Animal Control

Town of Fairhaven ADA Transition Plan

November 2024

Institute for Human Centered Design

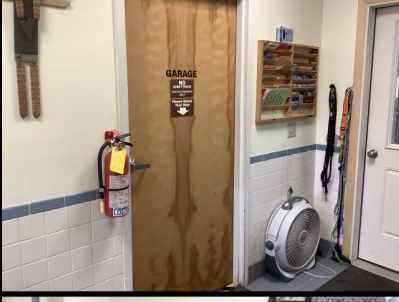
- Recommend providing a directional sign to the accessible route to Cat Room 3 through Cat Room 2.
- Recommend providing benches with backs and armrests.
- Recommend providing a 36” min. by 48” min. stable, firm and slip-resistant surface adjacent to at least one bench in each area where benches are provided positioned to allow a person in a wheeled mobility device and a person sitting on

the bench to have their shoulders aligned in a manner that is substantially similar to what is shown in the following diagram.
